**PINEHURST SUBDIVISION,**  
**RESUBDIVISION OF LOTS 12, 13, AND 14, BLOCK 23**

APPLICATION NUMBER 1 DATE March 15, 2007

REQUEST Subdivision

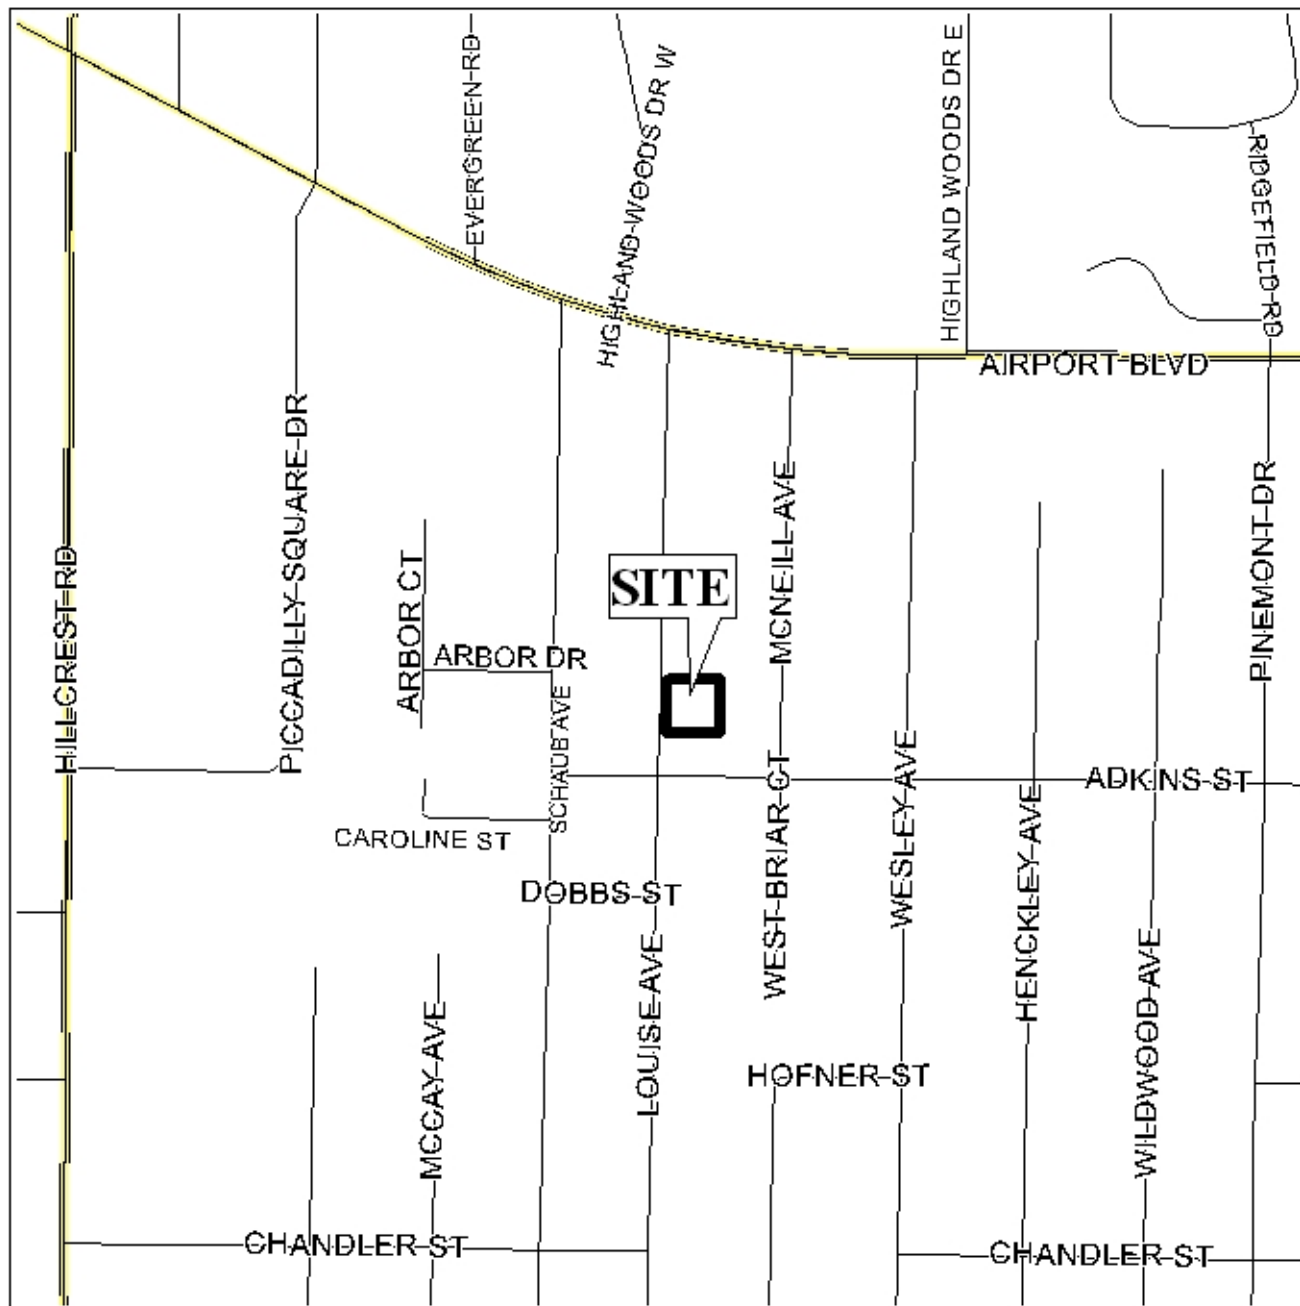
The plat illustrates the proposed 2 Lot / 0.5  $\pm$  Acre subdivision which is located on the East side of Louise Avenue, 105'+ North of Adkins Street, and is in Council District 6. The applicant states that the subdivision is served by both public water and sanitary sewer.

The applicant proposes to create two lots from three existing legal lots of record. The site is currently developed with a single-family residence, which will occupy one of the proposed lots if the subdivision is approved.

The site fronts Louise Avenue, a minor street lacking adequate right-of-way. As a minor street, the right-of-way for Louise Avenue should be at least 50 feet in width. Since the proposed subdivision will only result in two lots, the minimum building setback line, which is not reflected on the plat, should be depicted to show an additional setback sufficient to provide a right-of-way width of 25 feet, as measured from the centerline of Louise Avenue.

Although Louise Avenue is a minor street, access management is a concern. Each lot should be limited to one curb-cut, with the size, design and location to be approved by Traffic Engineering and comply with AASHTO standards.

Based upon the preceding, this application is recommended for Tentative Approval, subject to the following conditions: 1) depiction of the minimum building setback line to reflect a right-of-way width of 25-feet, as measured from the centerline of Louise Avenue; 2) placement of a note on the plat stating that each lot is limited to one curb-cut, with the size, design and location to be approved by Traffic Engineering and comply with AASHTO standards; 3) labeling of each lot with the total size in square feet; and 4) full compliance with all other municipal codes and ordinances.
